**JURUPA COMMUNITY SERVICES DISTRICT
RIVERSIDE, CALIFORNIA**

ADDENDUM NO. # 2

TO THE PLANS AND SPECIFICATIONS FOR
ANNUAL WATERLINE REPLACEMENT PROJECT
44TH STREET AREA
JCSD P.N. C245118
AND
GLENROY CT INTERTIE WATER PLAN
JCSD P.N. M221003

SCALE: NONE	3/4" OR 1" METER, 1" WATER SERVICE DETAIL (W/OUT RESIDENTIAL FIRE SPRINKLERS)	DRAWING NO. D-1
DATE: SEPTEMBER 2020	ALBERT A. WEBB ASSOCIATES CONSULTING ENGINEERS	
APPROVED BY: Sinnaro Yos, P.E. C68607	RIVERSIDE CALIFORNIA	W.O. 2023-3229

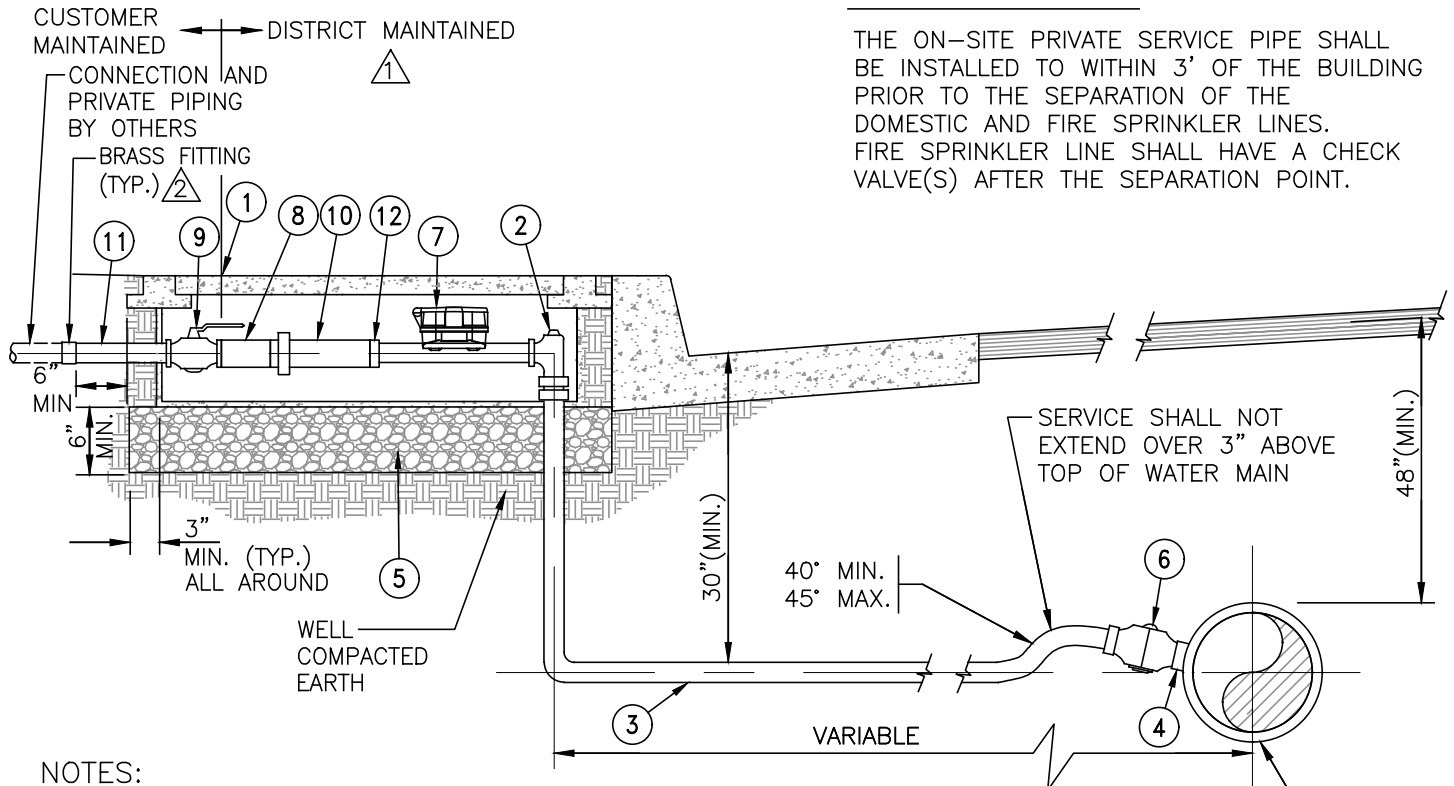
2. All references in the Contracting Bid Documents to District Standards **D-1, D-2, D-3, D-4** and **D-4A** are replaced with the revised details in **Attachment A** for this project.
3. Delete: Specifications Page B-3, Section 6, bullet point "Potential bidders who wish to submit a bid to JCSD must submit their bid electronically (PDF format – Volume II) to JCSD Bids, email jcsdbids@jcsd.us".
